Re: Groundwater consultant reply to DOI Water response to IPC questions

Attachment 1: Hume Coal's full reply to DoI Water's responses to the IPC's specific questions.

Attachment 1

Figure 1 Groundwater model interburden thickness – Model Layer 8

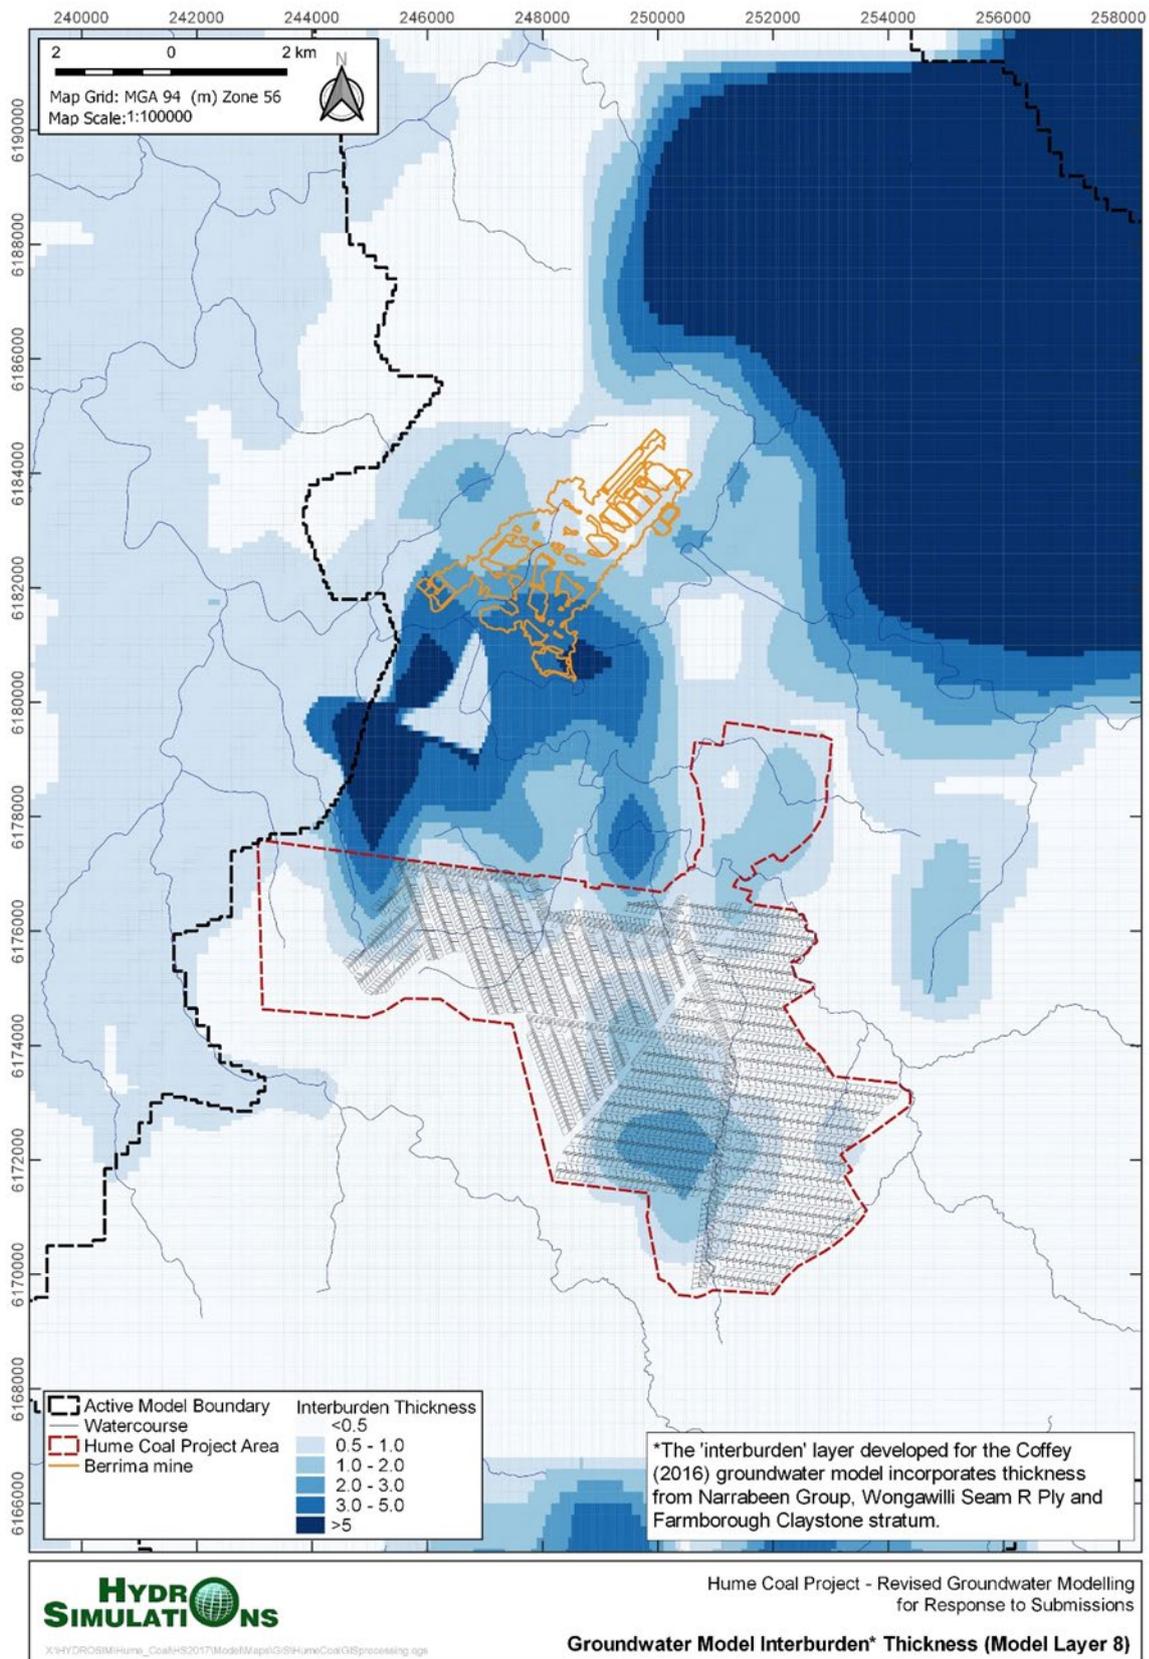
Questions remain as to the extent of the Narrabeen Formation directly above the coal seams and the adequate representation of this in the model (thickness of the interburden and hydraulic parameters chosen for the groundwater model).

With respect to the location and thickness of the interburden, there is continuing uncertainty with regards to the thickness of the interburden in the Modified EIS USG-T model. The thickness and therefore significance of the interburden is modelled differently to the conceptualization of it. (Figure 3 in HS2018/02 vs Figure 4.3 and 4.4 in GEOTLCOV25281AB-ACA). The numerical model interburden thickness attains 6 - 10 m while the conceptualization of it in the Coffey report barely attains 2 m thickness in the exploration licence area A349.

The representation of the 'interburden' in the model is layer 8. This thickness is shown in Figure 1, which has been generated for this response and has not been presented in previous responses.

The maximum thickness of layer 8 within the Hume Coal Project Area does not exceed 3 m but is mostly less than 0.5-m thick. The Layer 8 'interburden', is a combination of:

- the Narrabeen Formation (which clearly only occurs **outside of the A349 lease area**);
- the Wongawilli Seam R Ply; and
- the Farmborough Claystone (which occur within the A349 lease area).

The combination of these three geologies are lumped as Layer 8 in the model and represented in a newly generated Figure 1 below and are considered the official 'interburden' in the model.

Figure 5 Packer Test K distribution - reproduced from the EIS in 2017 (referred to as Figure 5.2 in GEOTLCOV25281AB-ACA, Coffey 2016)

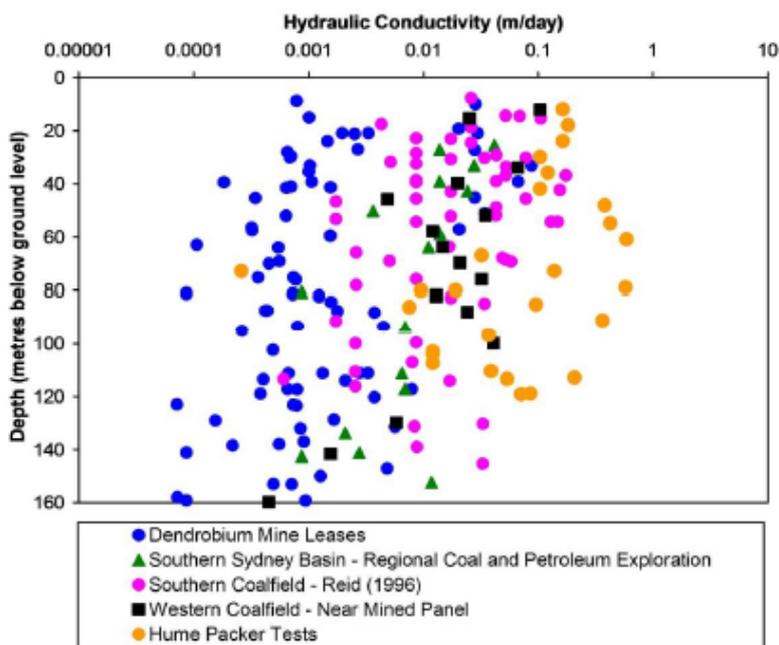
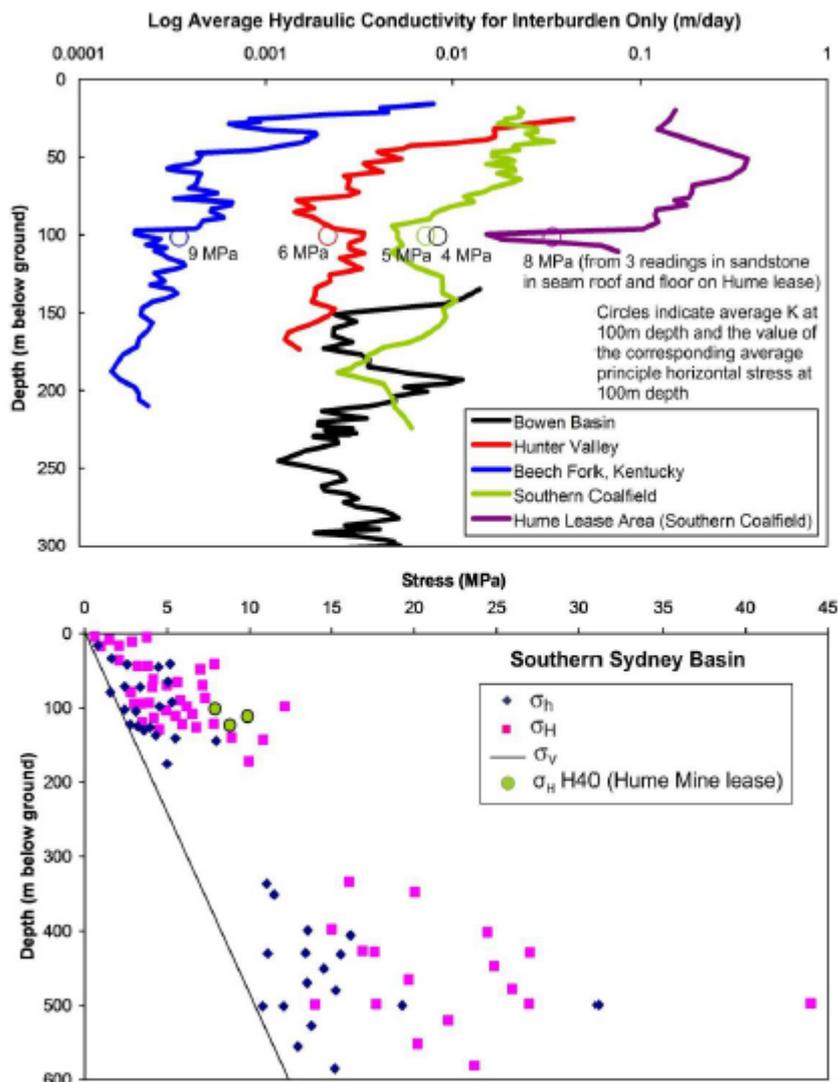
Dol Response: In summary, we do not believe that the data presented by the proponent demonstrates clear field evidence for the assertion that hydraulic conductivity decreases with depth. In addition, we believe that the behaviour of hydraulic conductivity in the vertical and horizontal directions can vary significantly in the aquifers present in the Hume Coal project area.

Dol Water Response: Dol Water experience from groundwater exploration drilling into fractured rock aquifer environments confirms that in such aquifers hydraulic conductivity in the vertical (K_v) and horizontal (K_h) directions is highly variable. In some situations K_v and K_h can be similar and in others K_v is higher than K_h . Increasing hydraulic conductivity with depth in such aquifers can also be common nor is it particularly rare even in primary porous aquifers.

The EIS data review by Coffey provided evidence for the decreasing K with depth based on available data and are reproduced here as Figure 5 (Figure 5.2 GEOTLCOV25281AB-ACA) and Figure 6 (Figure 5.4 GEOTLCOV25281AB-ACA). Decreasing K with depth is scientifically demonstrated in the literature and local data and the Coffey (2016) report states:

‘The relationship between the K field and principal horizontal stress magnitude was explored by considering only the stiffer media within the profile. This included general interburden (mostly sandstone) only and excludes coal seams. Figure 5.4 (**reproduced here as Figure 6**) shows the running 10-point log-average K down the depth profile for Permian Coal Measures (excluding coal seams) at a site in Kentucky (Hutcheson et al 2000a, 2000b), the Southern Coalfield (Reid 1996), the Hunter Valley, and the Bowen Basin, compared to the Hume area. Figure 5.4 also shows the measured principal horizontal stress in the Southern Sydney Basin (Hillis et al 1999) and three measurements undertaken on the Hume lease. **All five datasets identify a reducing K with depth**, caused by increasing overburden pressure. Average horizontal stress magnitudes for a depth of 100 m as estimated from field measurements are labelled at the average K for each K distribution. **Each distribution has approximately the same rate of decrease in K with depth, mostly caused by increasing overburden pressure (with media densities being similar between areas).**’

Figure 8 Box plot of EC of major groundwater

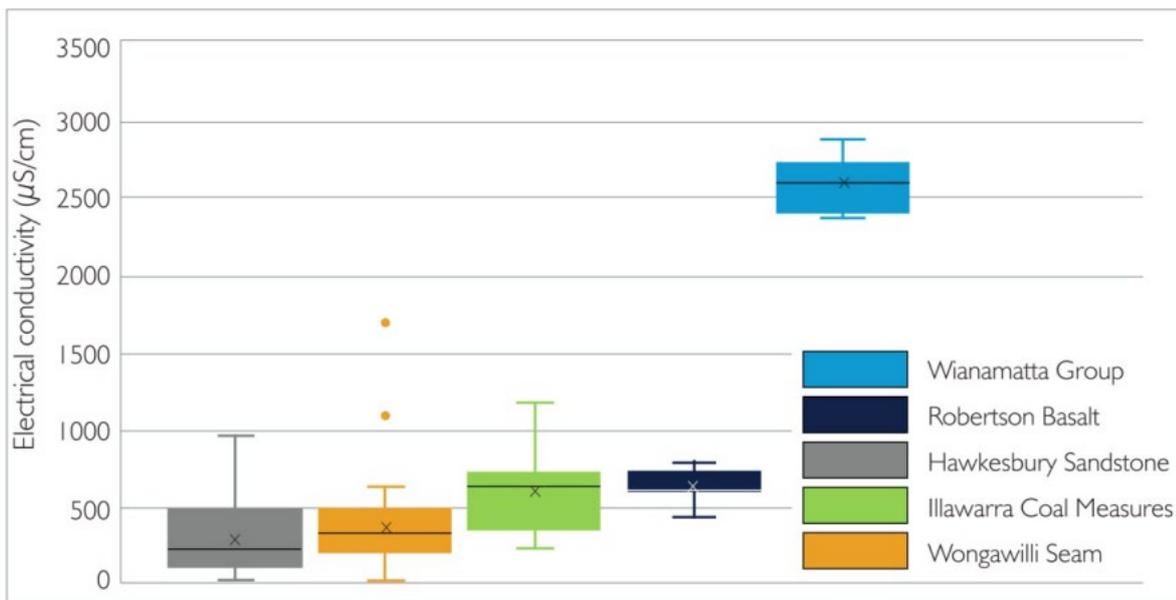
DoI Water Response: Typically bores that penetrate through the Hawkesbury Sandstone are lower yield and poorer quality. The Southern Highlands district in which the proposed mine is located is typically quite productive in terms of bore water supplies, due to a combination of influences including the structural setting, the recharge zone location and enhanced permeability of the Hawkesbury Sandstone.

Hume Coal acknowledge that the Hawkesbury Sandstone is the main water bearing formation in the area and that deeper formations are not as commonly utilised and may be of slightly poorer quality and lower yield. The location of the proposed Hume Coal mine in the recharge zone means that although slightly poorer in quality, there is actually a very close similarity in the freshness of the Triassic Hawkesbury Sandstone to the underlying Wongawilli Seam and Illawarra Coal Measures, which show a slightly increased but similar salinity signature (Figure 8).

Should lower yields be encountered, then drilling can include a combination of more than one bore; larger diameter bores; and or deeper bores with greater volumes of available head can be undertaken.
